**NEIGHBORS BRANCH/WALTON CRAWLEY BRANCH
STREAM & WETLAND RESTORATION SITE**

NCDMS Project No. 92872
Contract No. D09023S
USACE Action ID No. SAW-2009-917 & NCDWR Project No. 10-0122
SCO No. 08-07308-01
McDowell County, North Carolina

RE: Neighbors Branch/ Walton Crawley Branch Monitoring (DMS Project # 92879, Contract # D09023S)
Final Year 3 (2018) Annual Monitoring Report

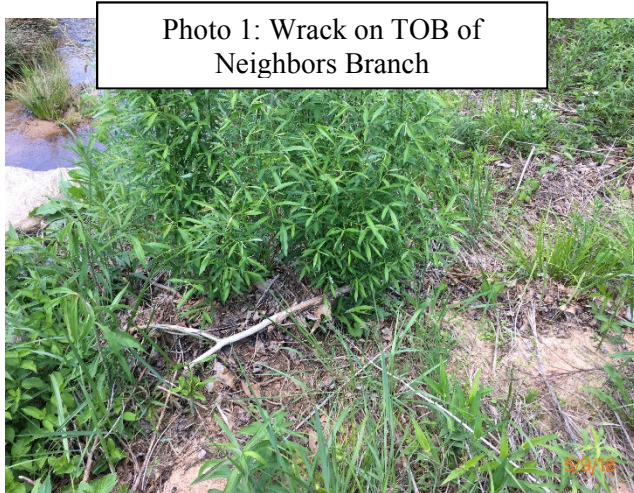
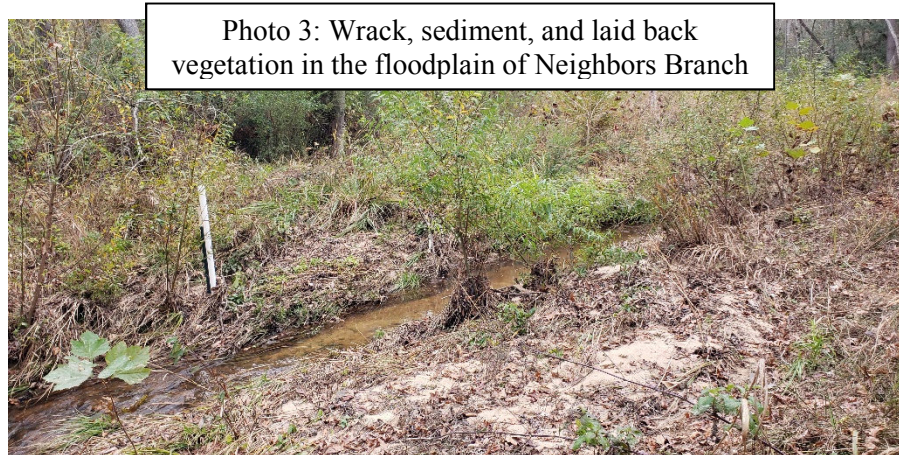
- Table 12: Description for bankfull event collected on May 9, 2018 references UT8. This must be for the Bob's Creek Project. Please update as necessary for the Neighbors Branch/Walton Crawley Branch project.
As the photos indicate, wrack was observed in the floodplains of Neighbors Branch and Walton Crawley Branch. The text in the table was revised to indicate this.
